<http://www.carson.org/Index.aspx?page=998> **NOTICE**
TO CONTRACTORS - BID #1415-143

BID TITLE "Carson City Animal Services Facility"
Labor Commissioner PWP# CC-2015-116
Engineer's Estimate: \$2,900,000
March 19, 2015

Addendum No. 3

1 1/2" MINI-BATTEN

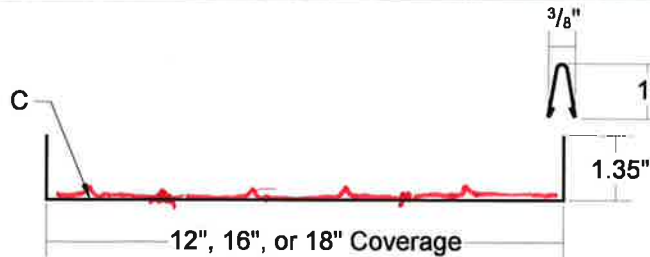
*Must include
Striations per
original spec.*

Approved as noted.

1 1/2" MINI-BATTEN

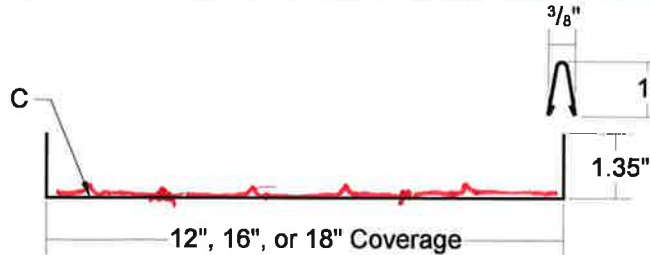
*Must include
Striations per
original spec.*

1 1/2" MINI-BATTEN

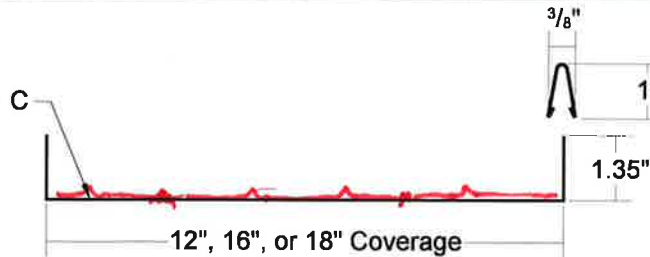
*Must include
Striations per
original spec.*
